Project	IEEE 802.16 Broadband Wireless Access Working Group <a href="http://ieee802.org/16">http://ieee802.org/16</a> >
Title	Changes on Sleep-mode SDL
Date Submitted	2004-03-08
Source(s)	Changjae Lee, Kiseon Ryu, Jay Jin LG Electronics,Inc. 533,Hogye-1dong,Dongan-gu, Anyang-shi,Kyongki-do,Korea  Voice: 82-31-450-4387 Fax: 82-31-450-7912 [mailto:cjlee16@lge.com]
Re:	This is a response to a Call for Comments IEEE802.16e-04/xx on IEEE P802.16e-D1
Abstract	This document contains suggestions to change the SDL on Sleep mode operation.
Purpose	This document is submitted for review by 802.16e Working Group members
Notice	This document has been prepared to assist IEEE 802.16. It is offered as a basis for discussion and is not binding on the contributing individual(s) or organization(s). The material in this document is subject to change in form and content after further study. The contributor(s) reserve(s) the right to add, amend or withdraw material contained herein.

# Changes on Sleep mode SDL

2. Proposed changes on Sleep mode operation SDL in IEEE P802.16e-D1

Figure 108d—Typical MSS Listening SDL Diagram

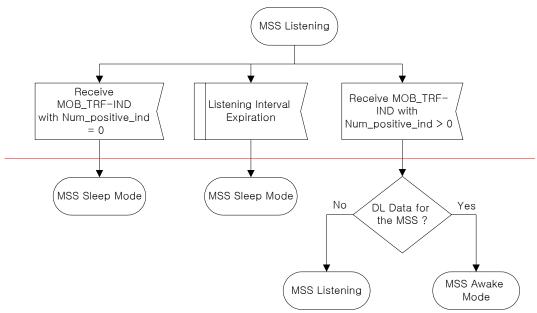
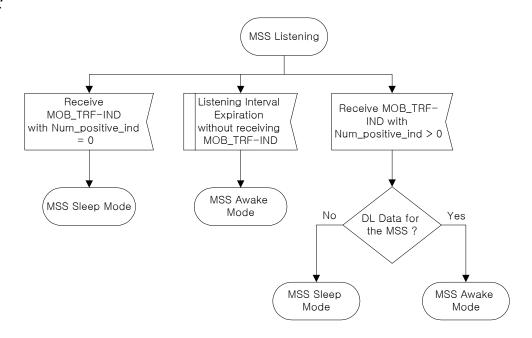
But, the Figure 108d at page 39 shows something wrong as follows.

- MSS returns to Listening mode in spite of the case of 2).
- There is no description about the case of 4) in the figure.

So, we propose changes on Sleep mode SDL in the Figure 108d at page 39.

# [Replace Figure 108d to the following at page 39:]
